**NOTICE OF ADDENDUM
ADDENDUM 1**

**CONTRACT NO. 9430
SPRECHER ROAD GREENWAY IMPROVEMENTS**

12960
U1

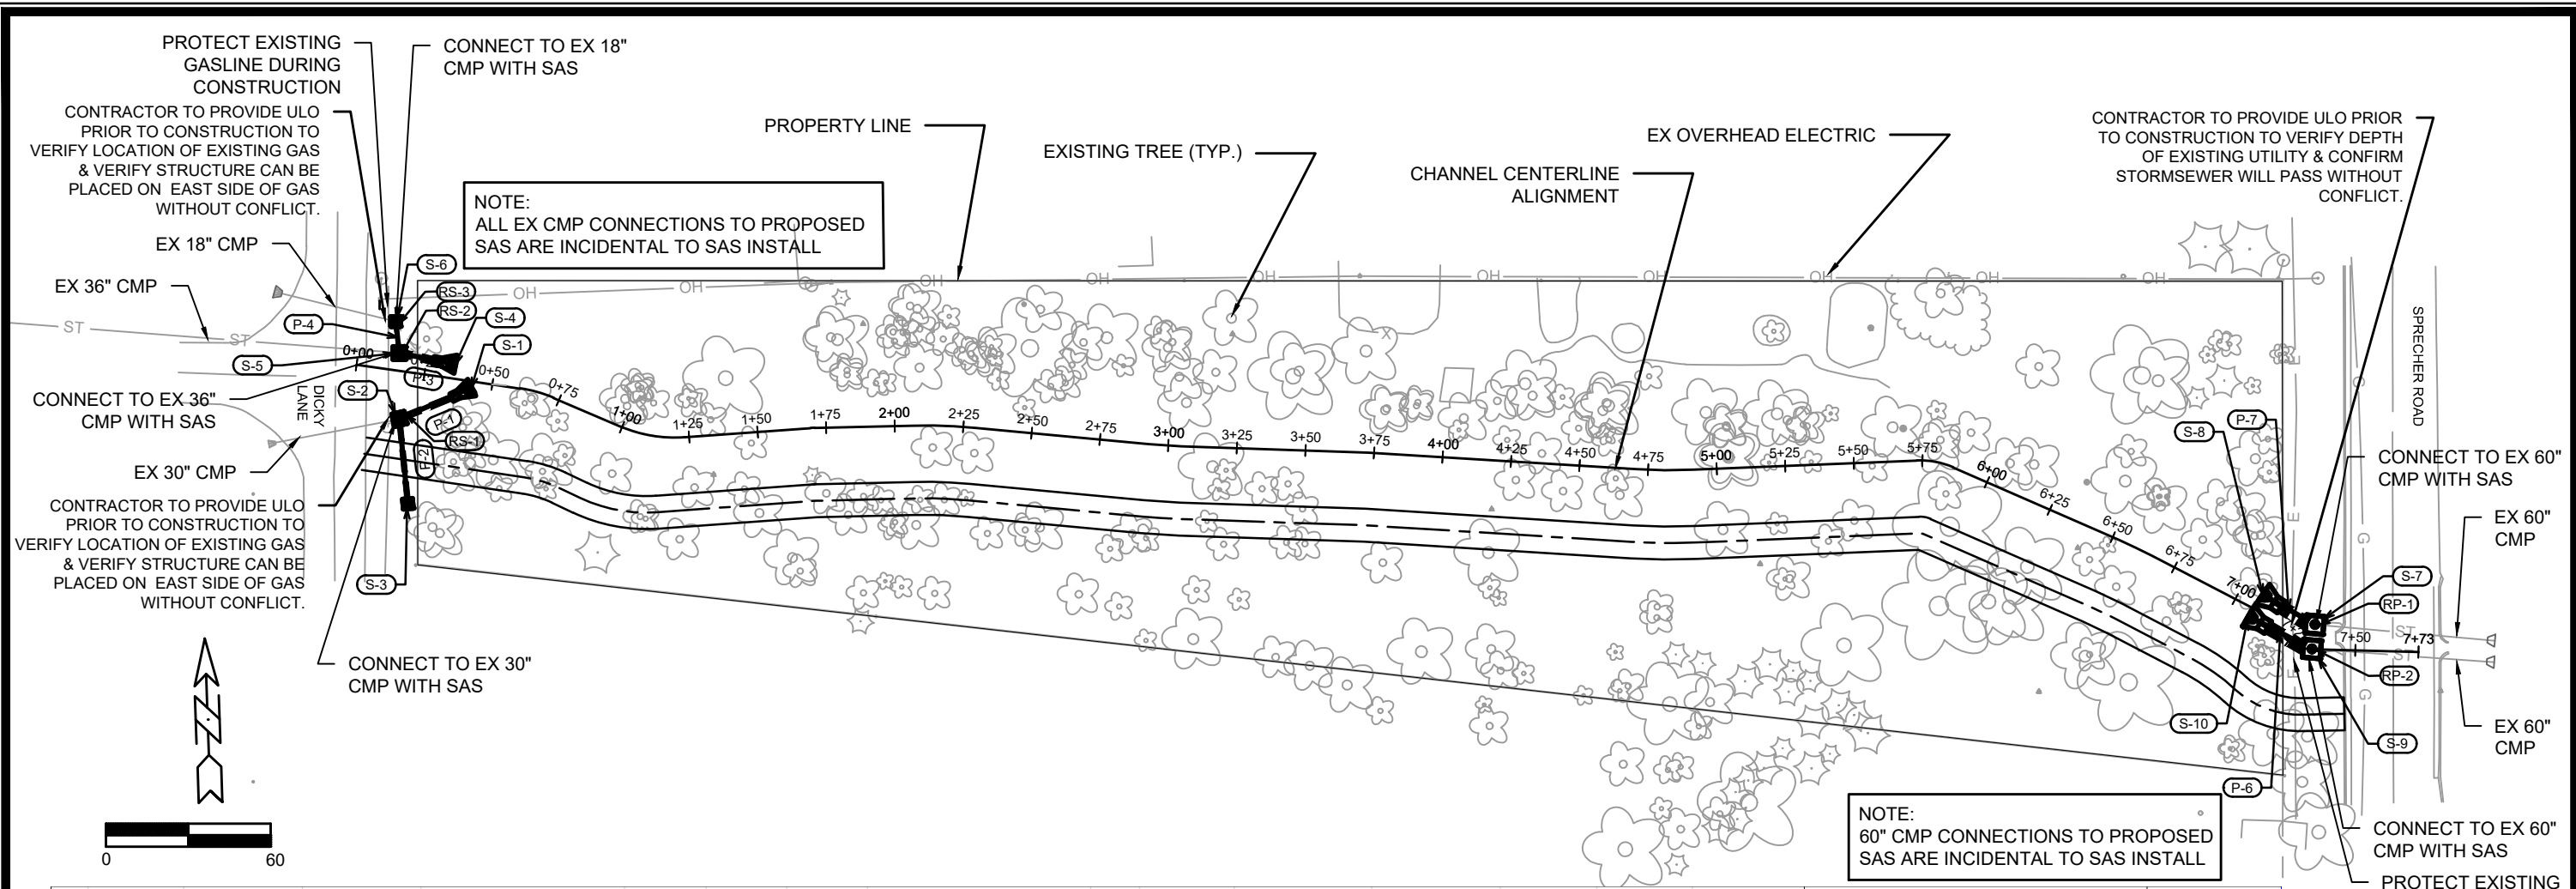
Remove and replace plan page U1 with attached plan page U1. Page U1 has been updated to call out the storm structures S-7 and S-9 as 6'x6' SAS in the storm sewer schedule. This will match the existing proposal sheet.
